REGULATORY INFORMATION DISTRIBUTION SYSTEM (RIDS)

SUBJECT: Forwards info on listed items in SER & technical evaluation
 rept of first 10-yr interval inservice insp program.

Subject: Docket Nos. 50-361, and 50-362
First Ten-Year Interval Inservice Inspection Program
San Onofre Nuclear Generating Station
Units 2 and 3 (TAC Nos. 54148 and 54149)

RELIEF REQUEST NO. B-7

Figure 1

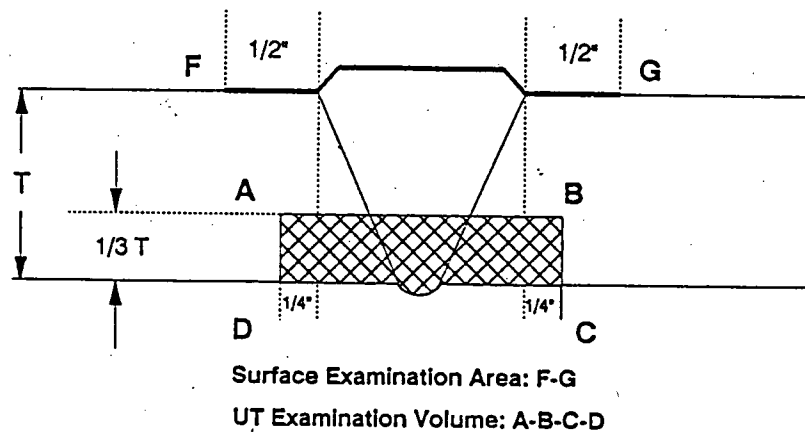
Relief Request B-7 requests deviation from the Code-required combination of "inner 1/3 volumetric examination plus surface examination" as shown in Figure 1 for pressure-retaining welds in pipes and fittings, Code Categories B-F, B-J and C-F, Items B5.50 (with the exception of dissimilar metal welds), B9.10, B9.20, B9.30, B9.40, C5.21 and C5.22.

ASME Section XI Code Required Examination
per Figure IWB-2500-8

Figure 2

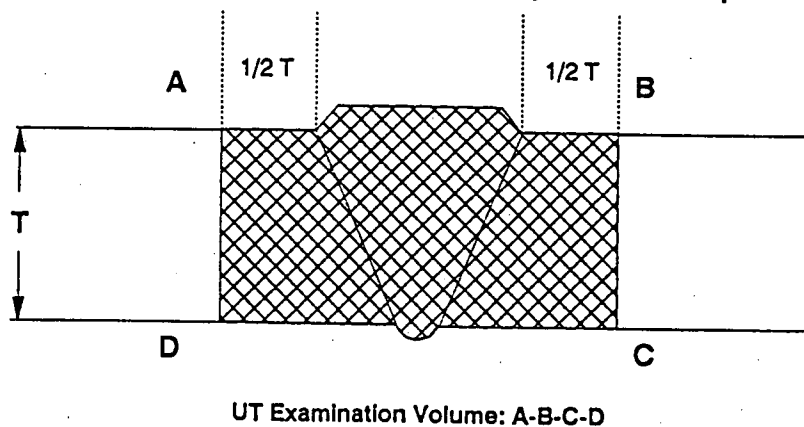
Volumetric examination of 100% of the volume of the weld and heat affected zone as shown in Figure 2 is proposed as the alternative examination. Examinations shall be conducted using full-vee examination techniques as a minimum, applied in two directions parallel to the weld, and two directions perpendicular to the weld, except when access is limited by weld configuration or geometry.

Proposed Alternative Examination per Relief Request B-7

Applicable circumferential and longitudinal pressure retaining piping welds will receive a 100 percent volumetric UT examination in lieu of a "1/3 volumetric plus surface" examination. Examinations shall be conducted using full-vee examination techniques as a minimum, applied in two directions parallel to the weld, and two directions perpendicular to the weld, except when access is limited by weld configuration or geometry.
